CHANGE LIST

Model  
CT3/5 MB BOARD

CT3/5 MB  
31CT3MB0015  
31CT3MB0031

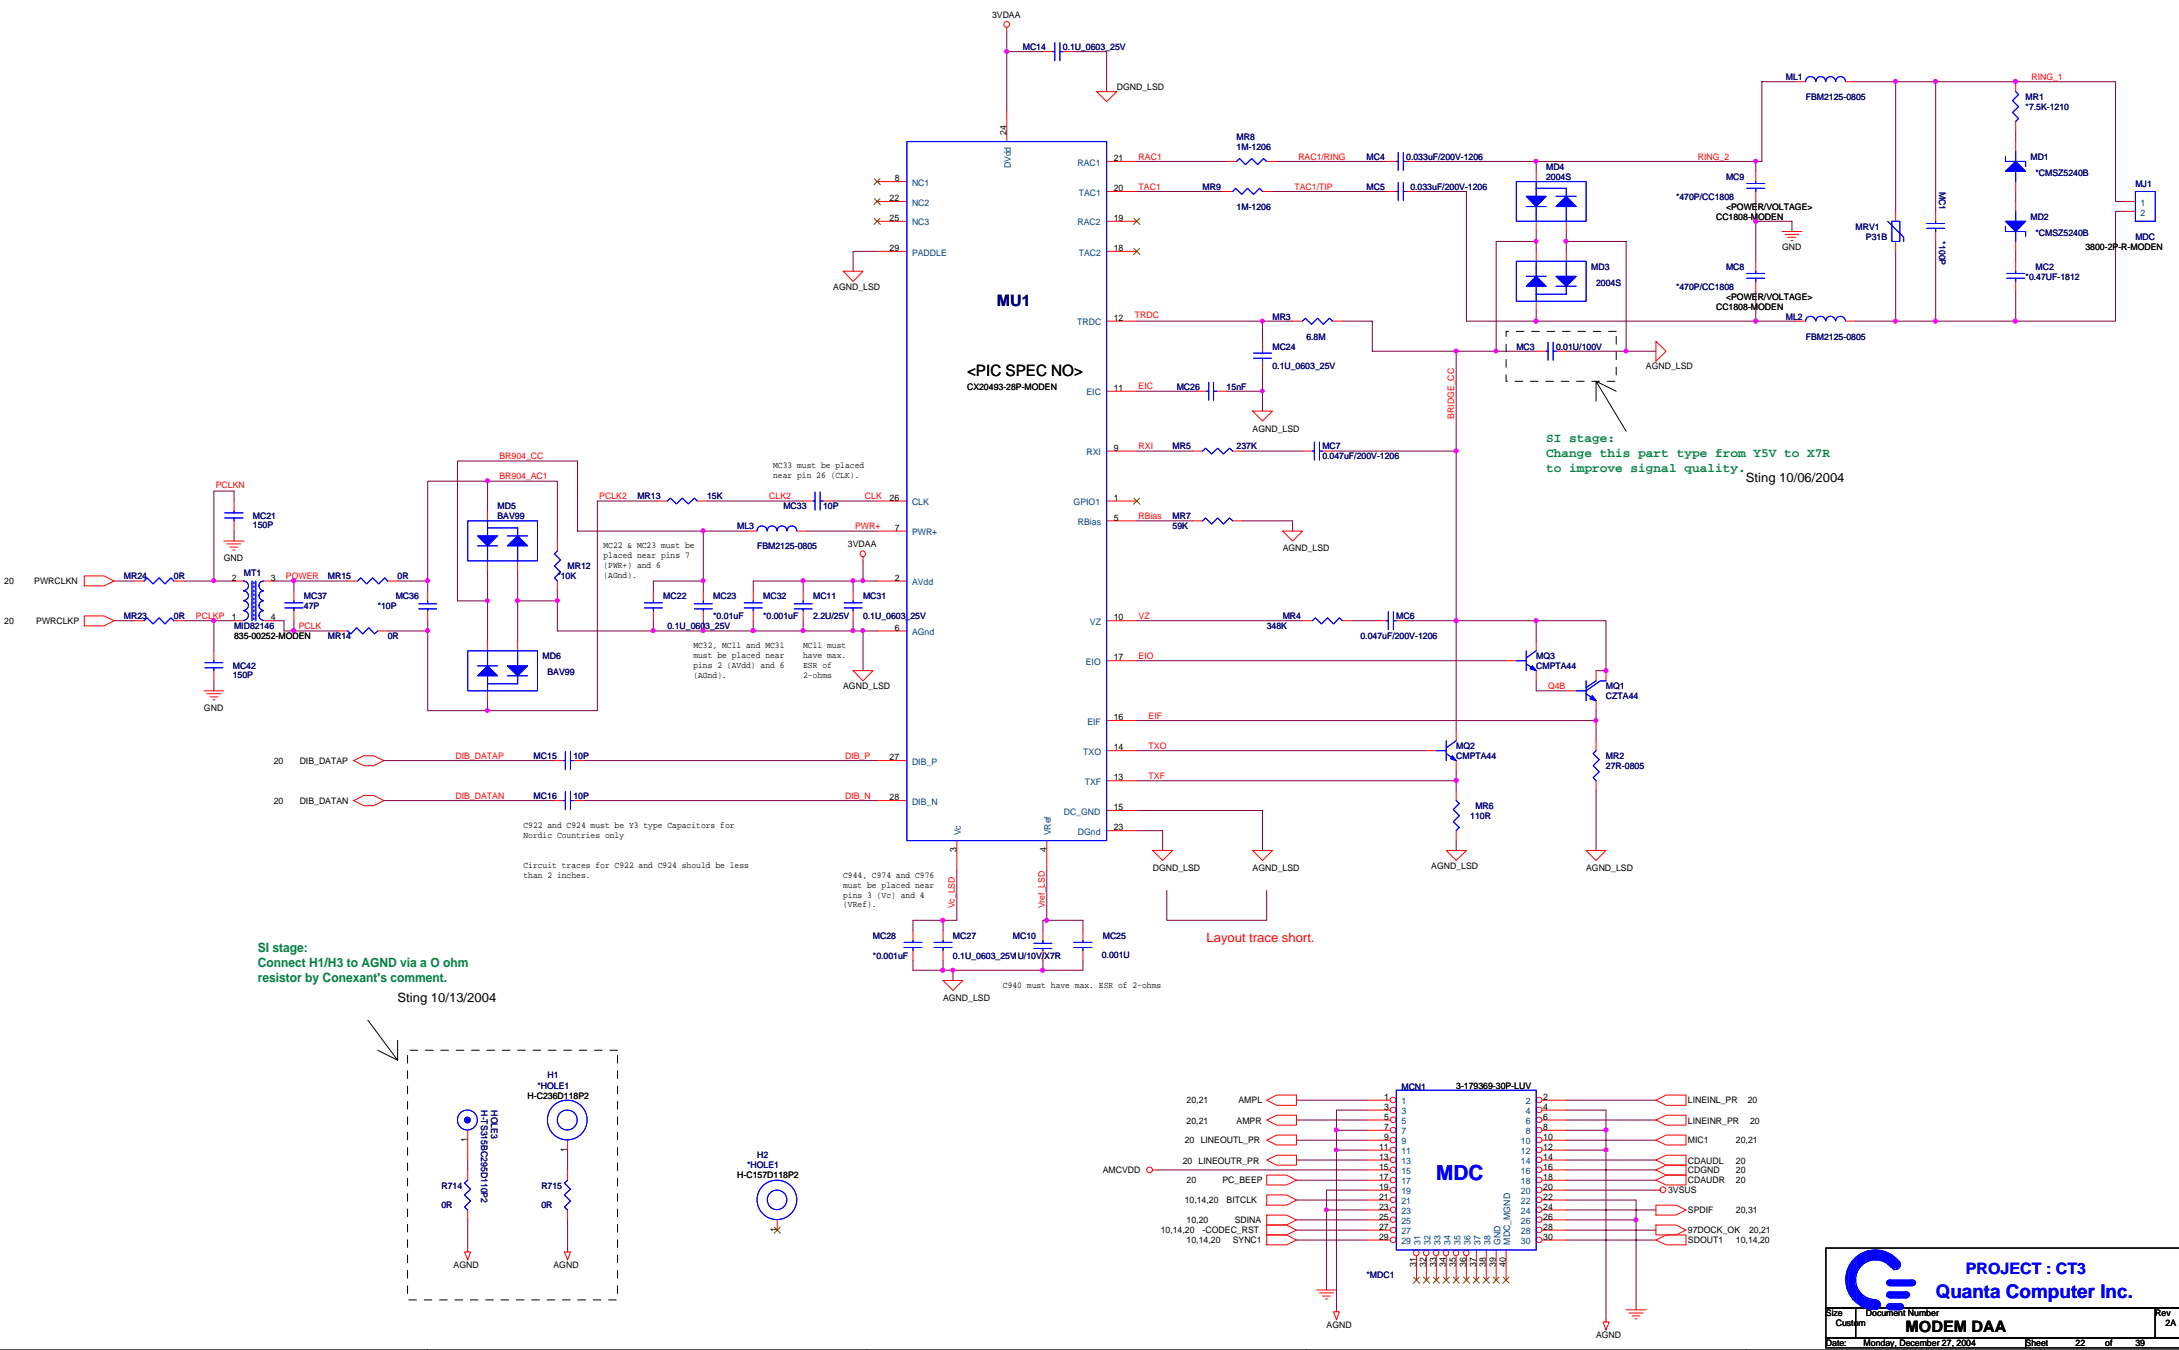
SI stage:  
Connect H1/H3 to AGND via a 0 ohm resistor by Conexant's comment.

C944, C974 and C976 must be placed near pins 3 (Vcc) and 4 (Vref).  
C940 must have max. ESR of 2-ohms

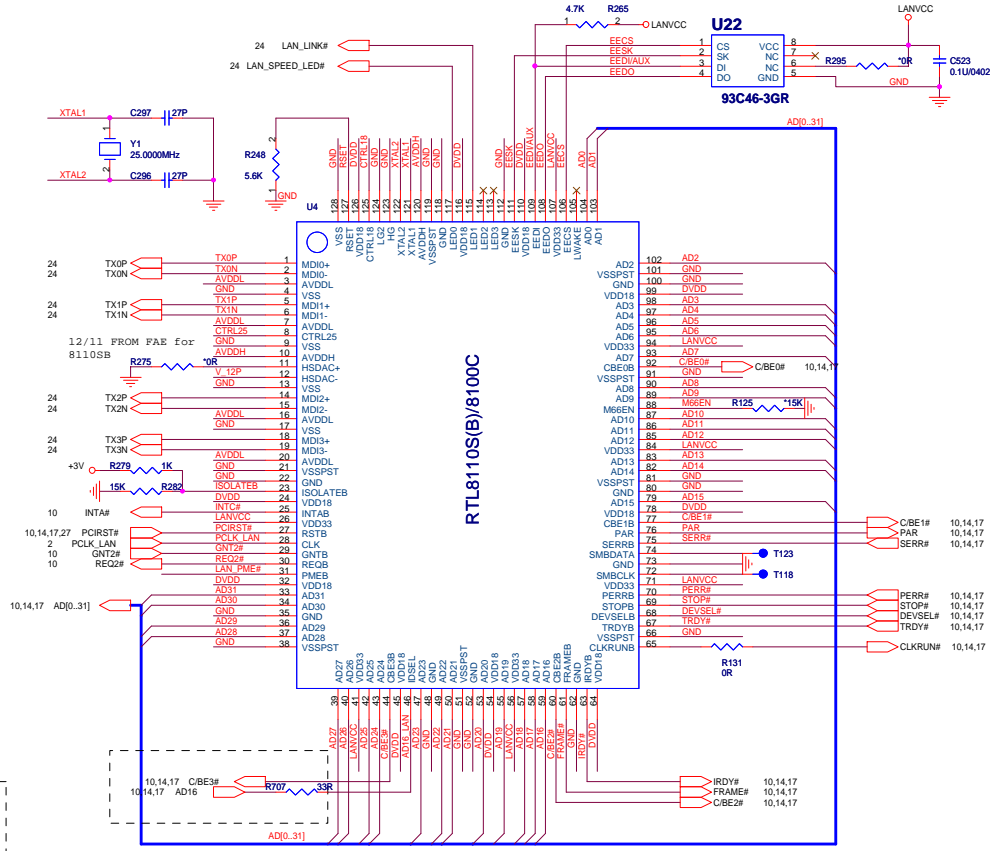
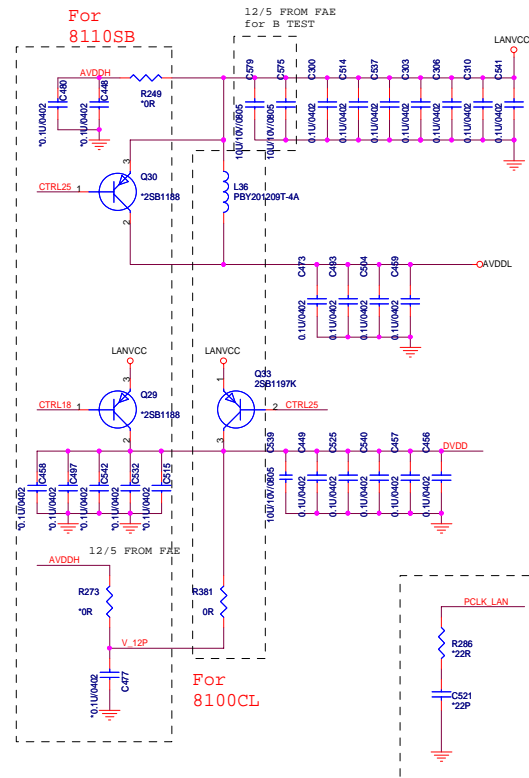
SI stage:  
Add a 0.1uF to make Q40 turn on slowly, because 3VPCU will drop when LANVCC turned on quickly. it will make EC state machine crazy.

SI stage:  
Add R707 for ID selection of Lan controller.

SI stage:  
Modified transformer circuit for 10/100M application.

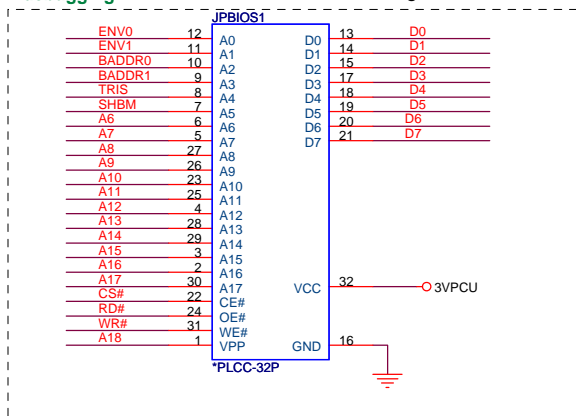
SI stage:  
 Add PLCC32 cause of it is convenient for Bios debugging.  
 Sting 10/01/2004

# KBC-NS87551L

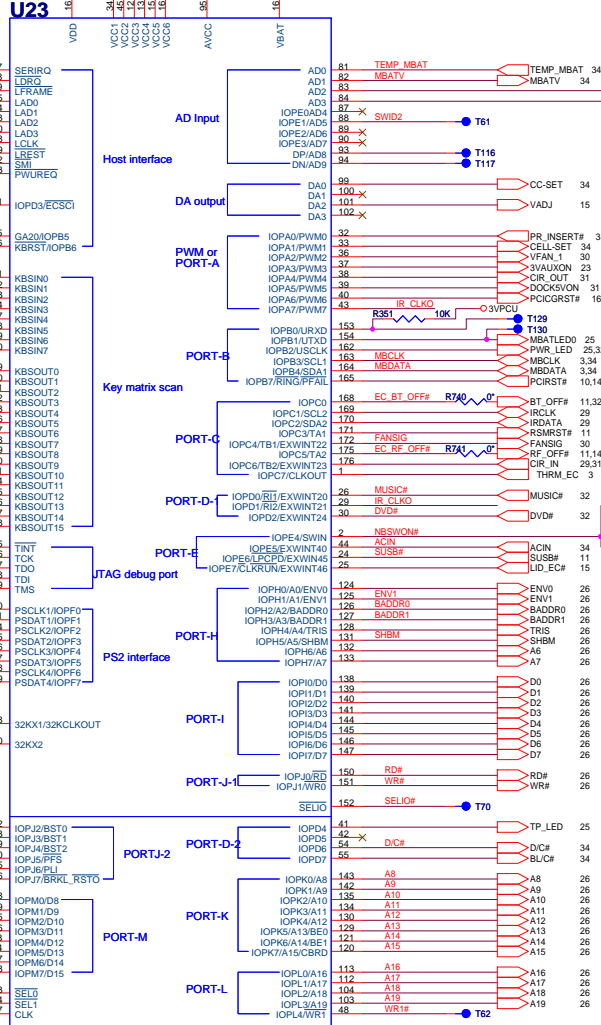
SI stage:  
Change R352 value from 120K to 20M.  
Sting 09/24/2004

SI stage:  
Add LPC debug port for software team to debug convenient.

PV stage:  
1. Reserve 0R for RF\_OFF# and BT\_OFF# circuit.

PV stage:  
Modify pin name.

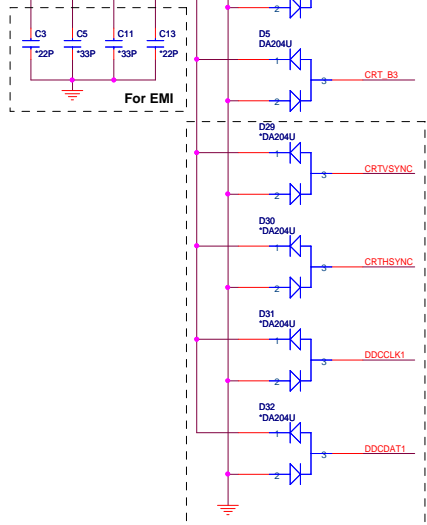
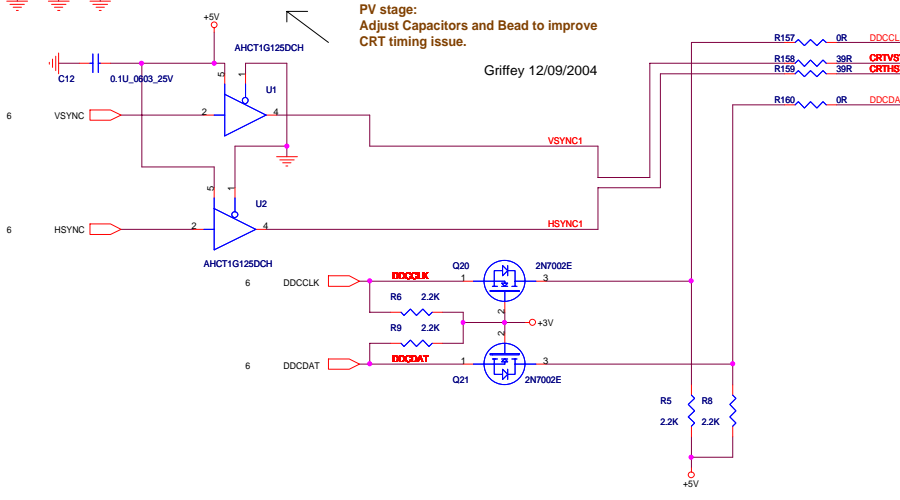
Intel has required that the termination resistor (150 ohm) should be placed at both side of GMCH and DB15.

PV stage: Adjust Capacitors and Bead to improve CRT timing issue.  
Griffey 12/09/2004

1. Change L66, L67, L68 from BK1608HM470 to 0R.

2. Remove C931, C932, C933.

3. Change C934, C935, C936 from 22P to 5.6P.

4. Change C6, C14, C350 from 10P to 5.6P.

5. Change L1, L26, L27 from BK1608HM470 to BLM18BA750SN1T.

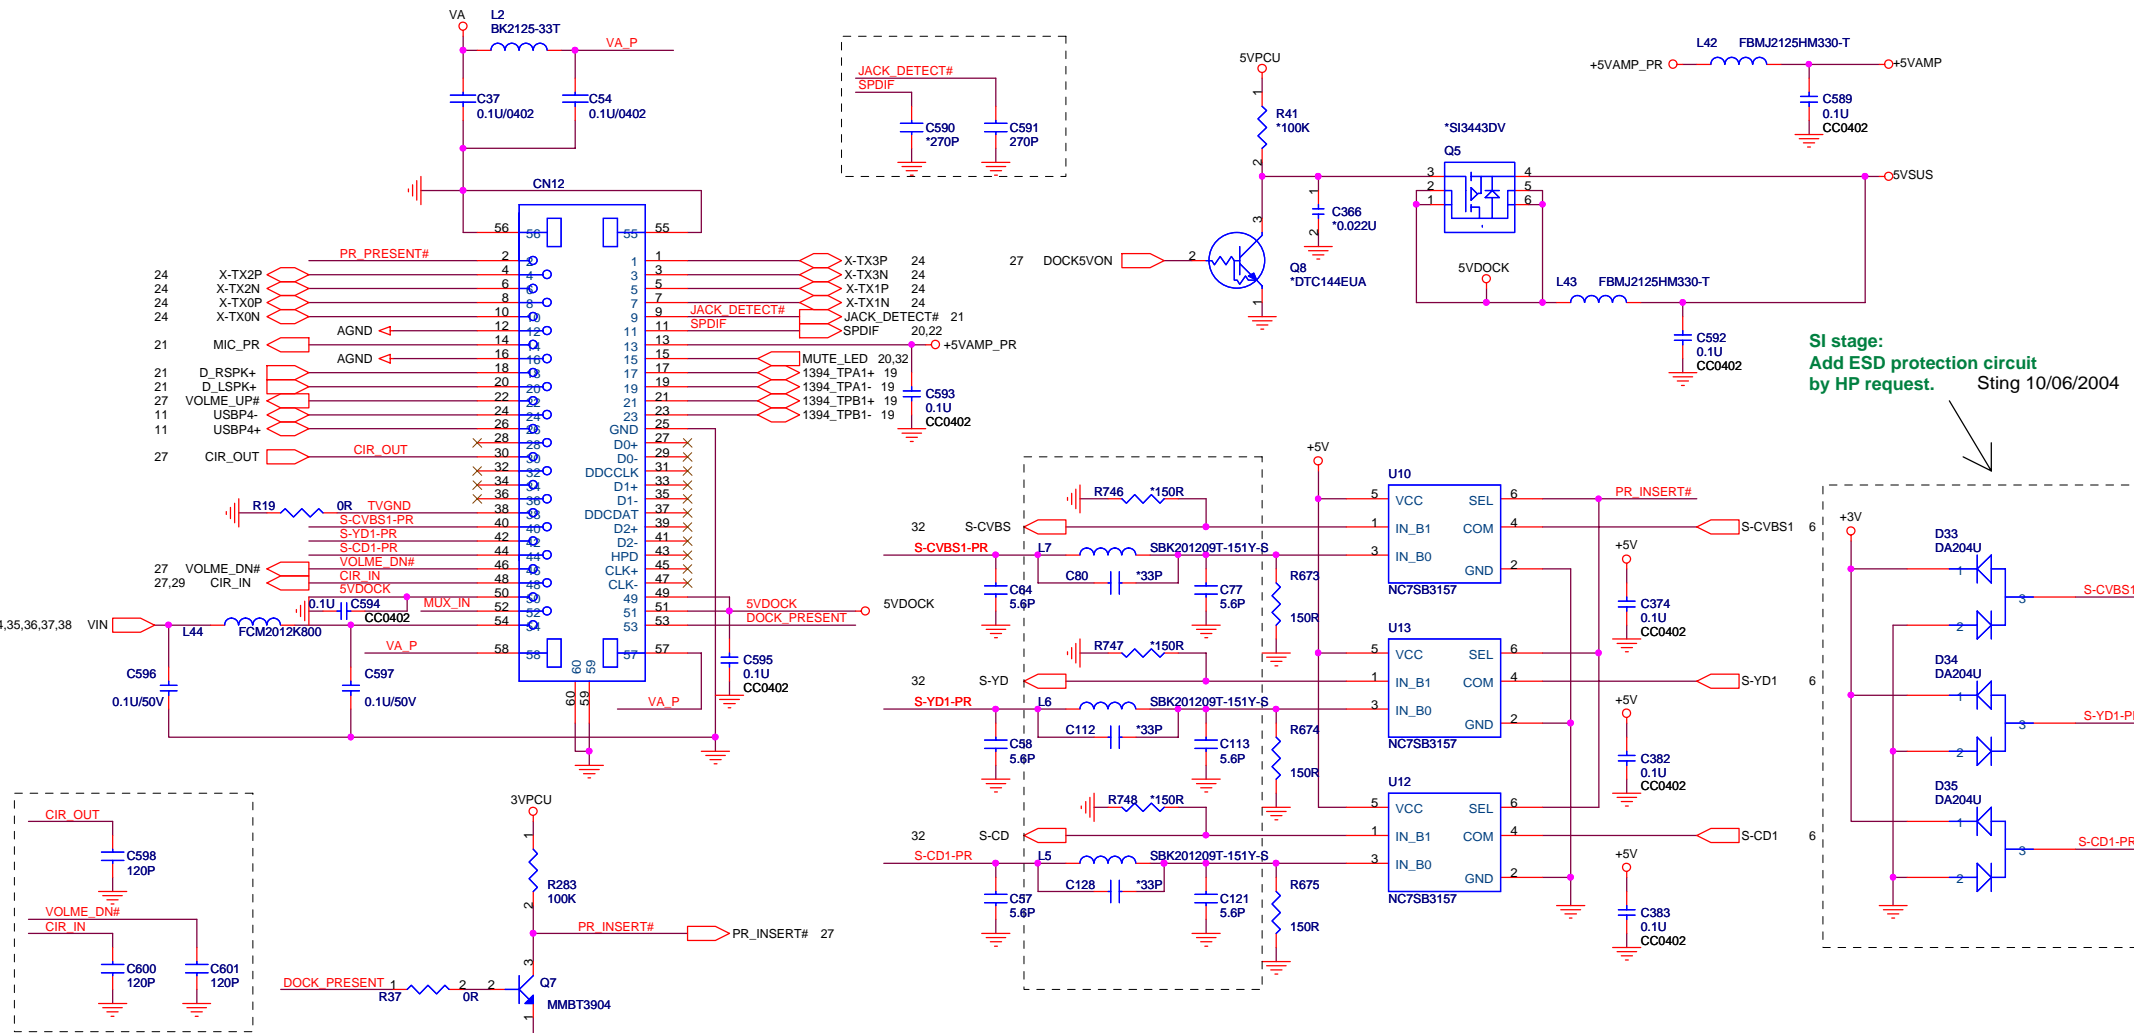
SI stage: Add GMT solution for B-test to costdown.  
Sting 09/24/2004

SI stage:  
Add ESD protection circuit  
by HP request. Sting 10/06/2004

**PV stage:**  
1. Change L5,L6,L7,C57,C58,C64,C77,C113,C121 value to improve S-video quality.  
2. Reserve S-video impedance match circuit.

SI stage:  
Add R713 to enable the mux in the Tampa-2 cable.  
(connects the component TV output to the composite/Svideo output lines).

# CPU VCC\_CORE (MAX1907)

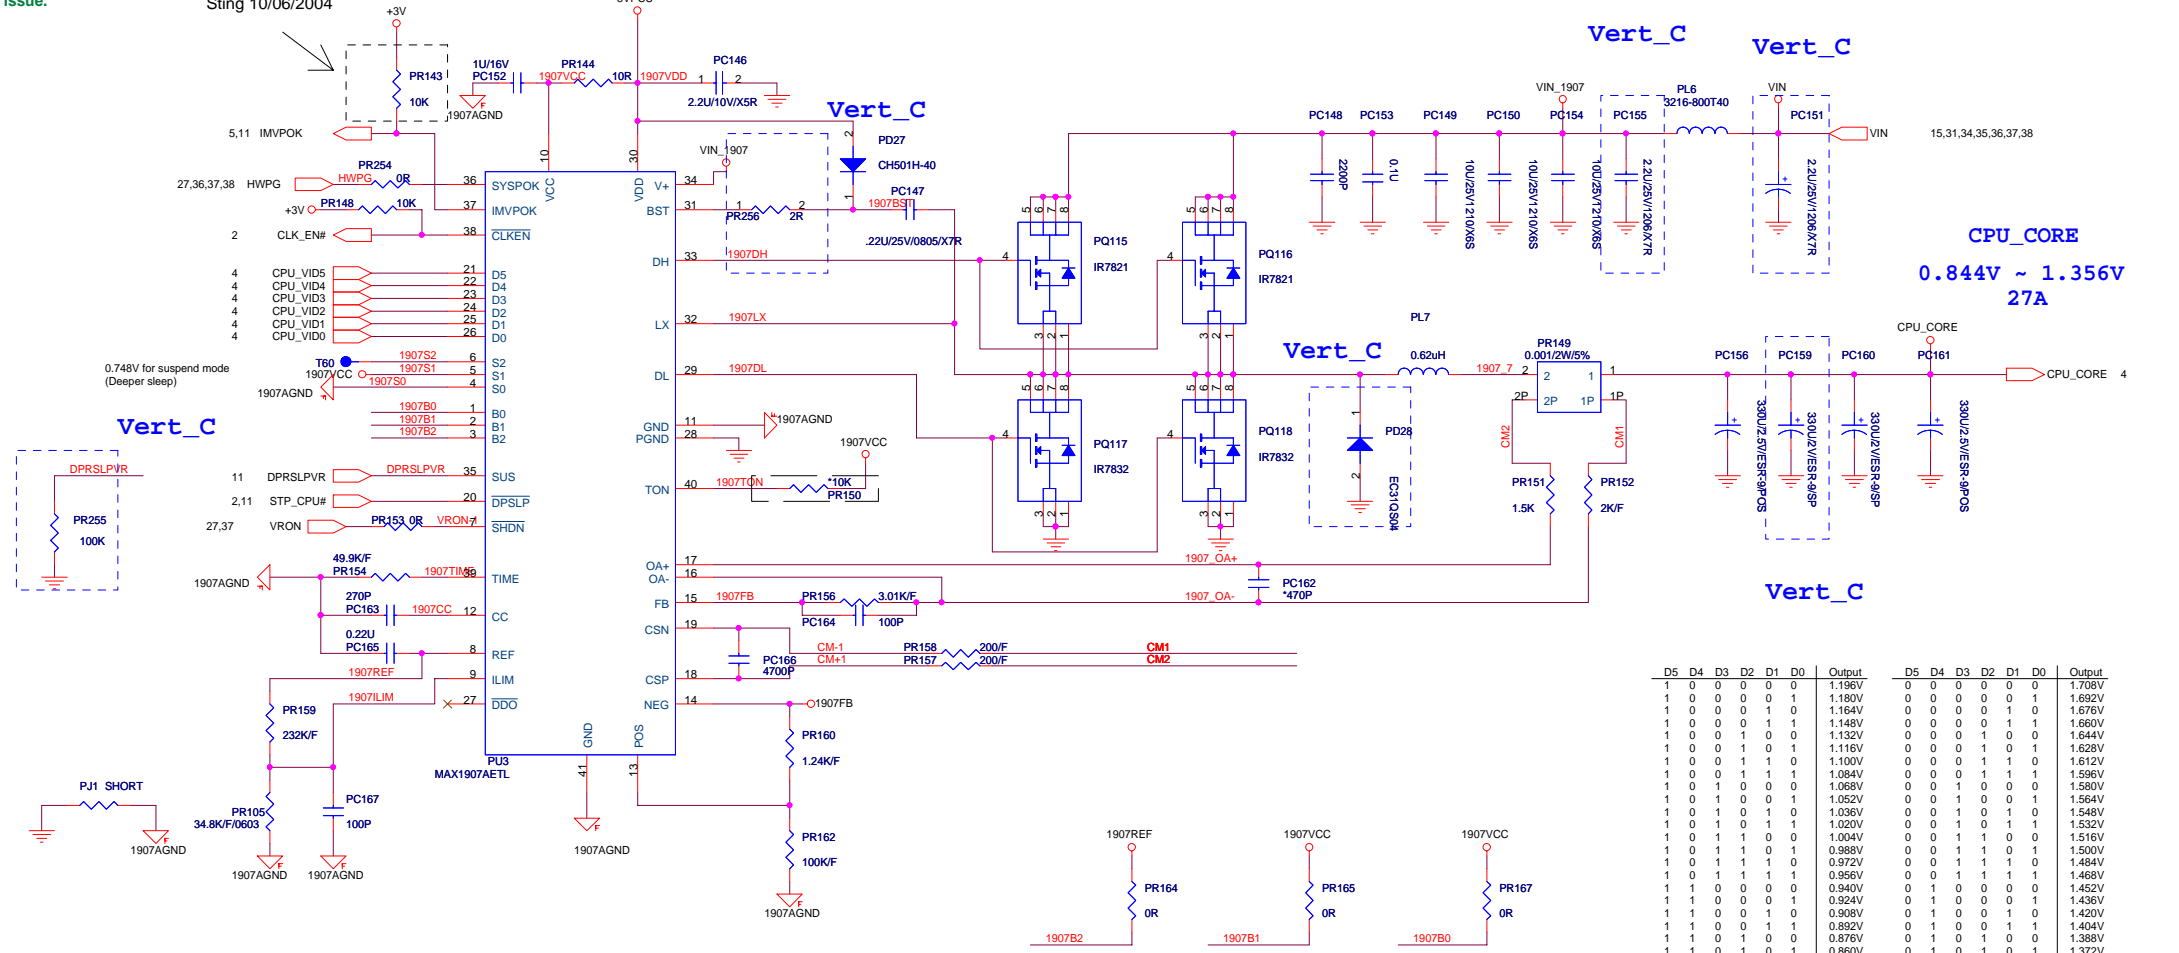
SI stage:  
Change PR143 value from 100K ohms to  
10K ohm to solve panel display abnormal  
issue.

Size	Document Number	Rev
Custom		2A
<b>DISCHARGE</b>		
Date:	Monday, December 27, 2004	Sheet 35 of 39

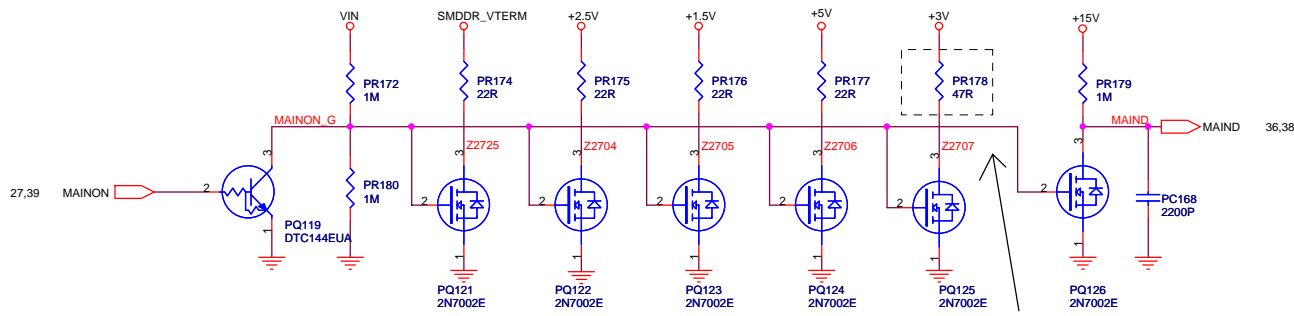
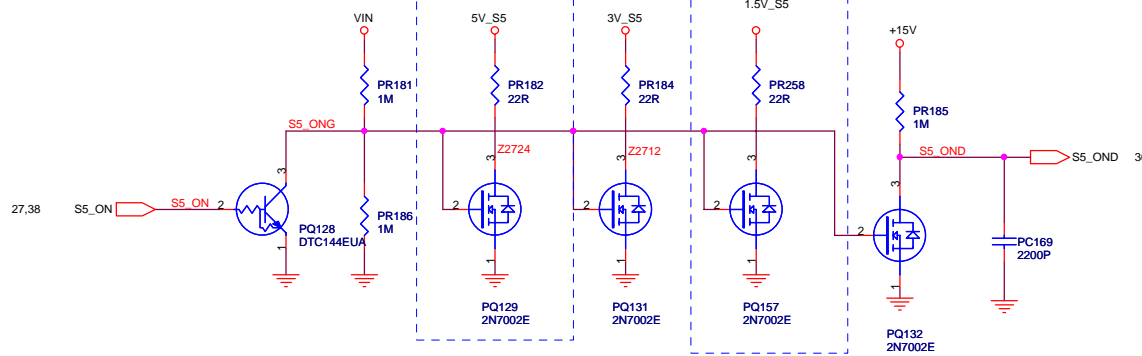
SI stage:  
Change PR178 value from 22 ohm to 47 ohm, Intel has required the timing sequence of +1.5V and +3V in the system, we'd like to increase the value to make +3V discharge slowly to meet the specification of falling time.
